**RE: EAST 4TH STREET IMPROVEMENTS
MILLER, SOUTH DAKOTA
SPN #16164**

ADDENDUM NUMBER 1

PERFORATED DRAIN PIPE BEDDING DETAIL

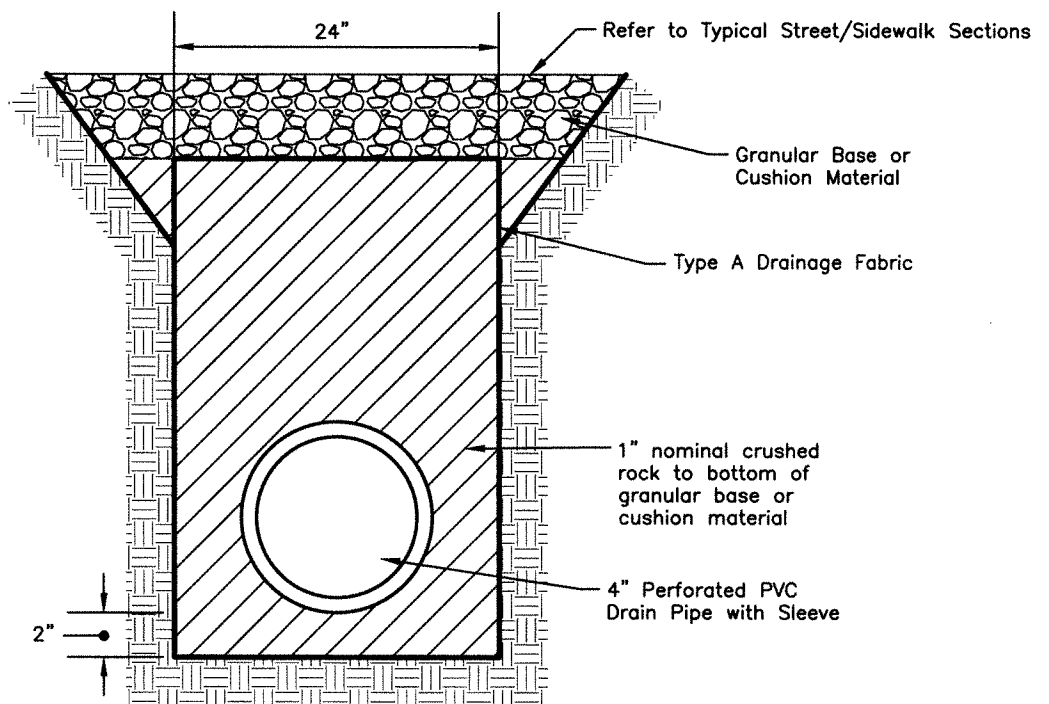
Sheet 44, Perforated Drain Pipe Bedding Detail, shall be removed in its entirety and replaced with the attached detail.
